HISTORIC PRESERVATION COMMISSION

SUBJECT: Historic Area Work Permit # 1057416 - sidewalk

Subject: RE: 4600 Waverly Avenue, Garrett Park (HAWP #1057416) Sidewalk

Town of Garrett Park Historic Preservation Committee Statement on Replacement Sidewalk and Trees 4600 block Waverly Avenue February 12, 2024

RETAINING WALL CURB

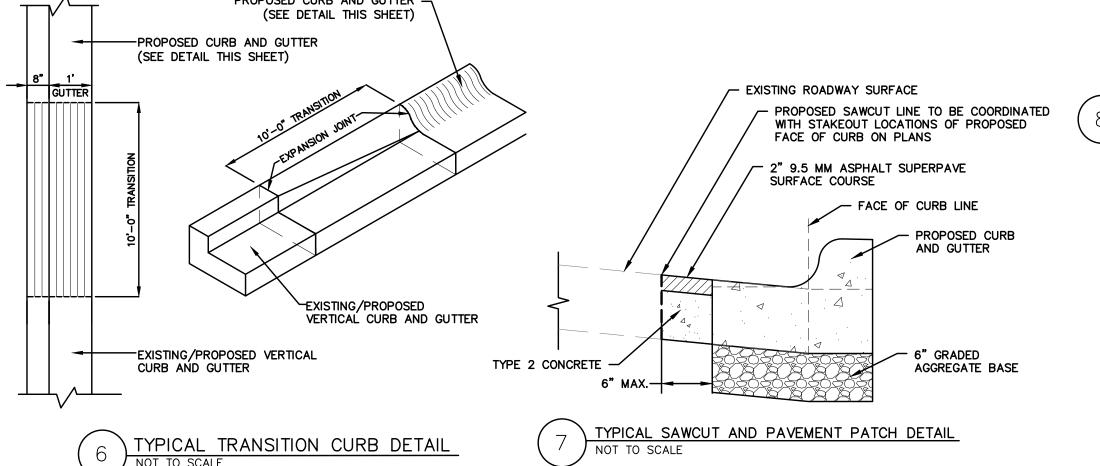
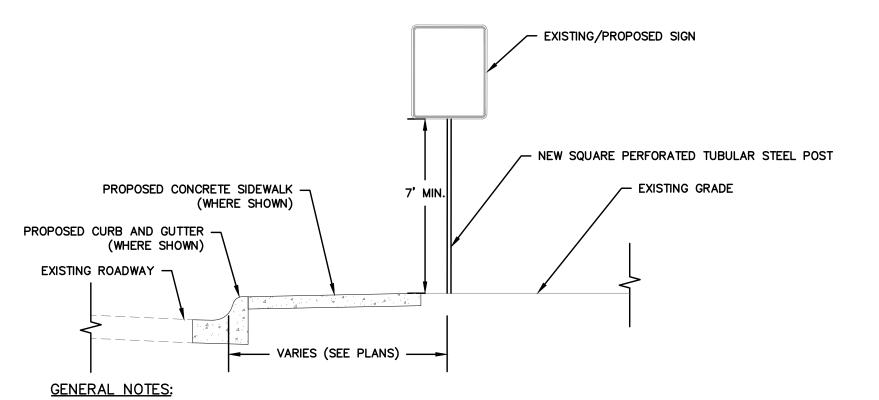
We have received your application to replace and expand the sidewalk along Waverly Avenue. The plan also shows a retaining wall, stairs, and railings close to the sidewalk. Will those be built as part of the sidewalk project? If so please provide details on those proposed features including materials and dimensions. Representative photos may also be helpful.

I apologize for any confusion. There will not be a retaining wall but rather a retaining curb. It is a max of 1.5' tall and monolithic with the sidewalk. Attached is the detail sheet with the retaining curb. Page 2 shows a detail of the stairs.
